Interactive comment on “How large does a large ensemble need to be?” by Sebastian Milinski et al.

Anonymous Referee #1

Received and published: 22 January 2020

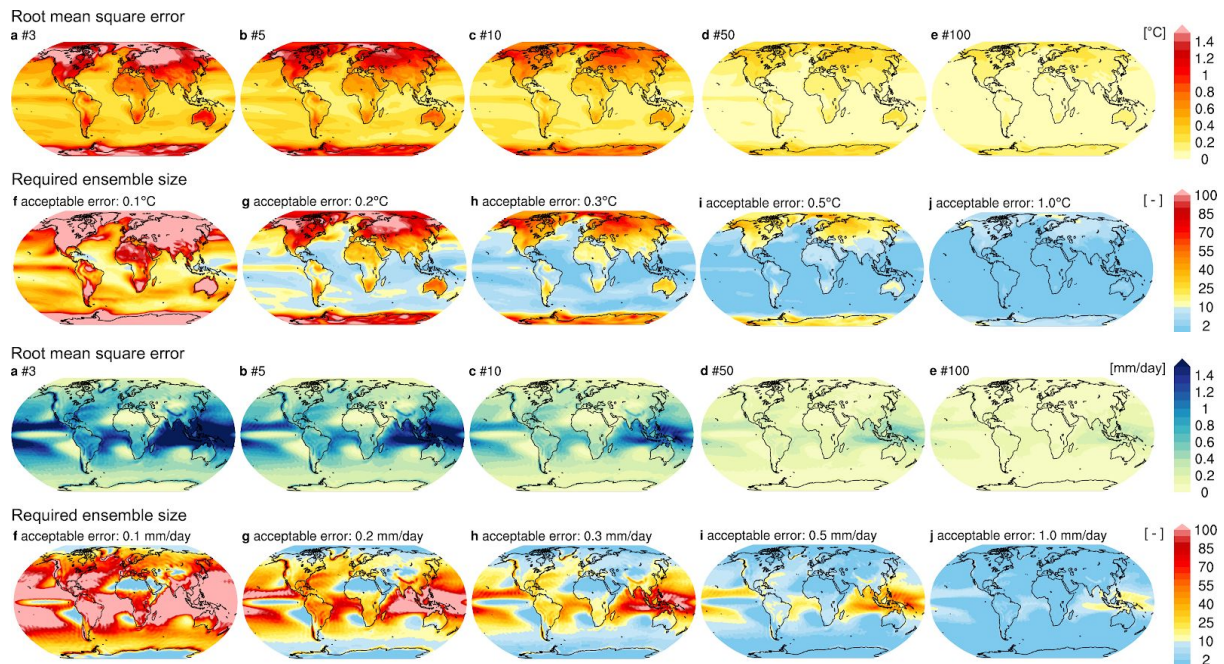
15. Fig. 3:
 - The caption should obviously be re-written and clarified.
 - Results would be more clear by inverting the order of plotting, that is red to light blue from top to bottom.
 - How can a standard deviation have negative values ?

Apologies for including an old caption in the submitted manuscript. The figure was updated, but not the caption. The caption should read:

PDF of ensemble-averaged Niño3.4 standard deviations possible in the MPI-GE pre-industrial control simulation for subsampling ensembles ranging from 50 to 1000 members (shown as different colors) for smaller ensemble sizes. Each PDF is shown relative to the corresponding ensemble mean value. We use the last 1000 years of the 2000 year control run to calculate the ranges. The Niño3.4 standard deviation is calculated over 50 year periods. The PDFs are created by resampling the control simulation 1000 times. For each PDF the entirety of the 1000 years are used (i.e. the blue 500 member pdf is the mean of 2 500 members PDFs).

We will invert the order of plotting as suggested.

The standard deviation is relative to the mean value, this is now clarified in the caption.
